[Docket No. 2003-NE-52-AD; Amendment 39-13381; AD 2003-24-12]

Airworthiness Directives; Pratt & Whitney JT9D-3A, -7, -7A, -7F, -7H, -7AH, and -7J Turbofan Engines

SUMMARY: The FAA is adopting a new airworthiness directive (AD) for Pratt & Whitney (PW) JT9D-3A, -7, -7A, -7F, –7H, –7AH, and –7J turbofan engines, with gearbox pressure tube, part number (P/N) 697896, and No. 4 bearing front pressure manifold, P/N 670663, installed. This AD requires a one-time visual inspection of the gearbox pressure tube and No. 4 bearing front pressure manifold and the attaching clamp assemblies for correct positioning and for wear and damage, and replacement if necessary. This AD is prompted by a report of a failed gearbox pressure tube that resulted in an engine fire. We are issuing this AD to prevent engine fires caused by failed gearbox pressure tubes or failed No. 4 bearing front pressure manifolds.

Figure 1

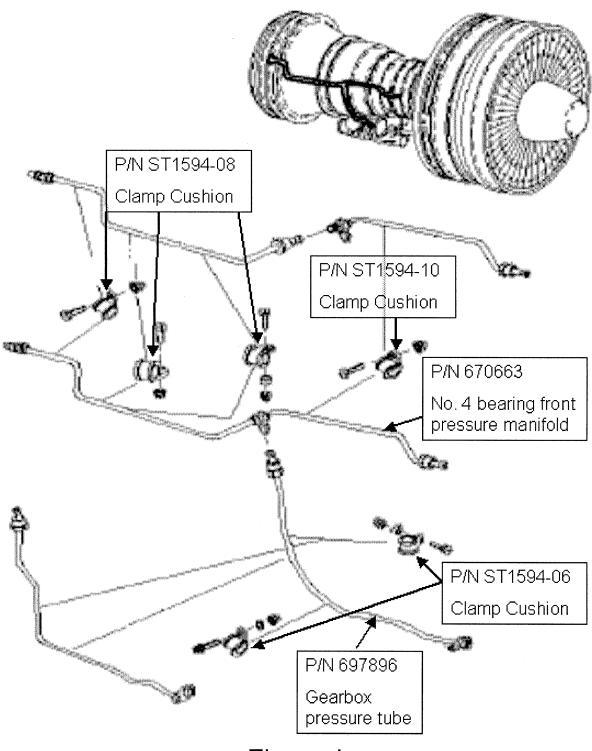
(h) If the gearbox pressure tube, No. 4 bearing front pressure manifold, or clamp assemblies are not properly positioned, then correctly position them before further flight, as shown in the following Figure 1 of this AD.
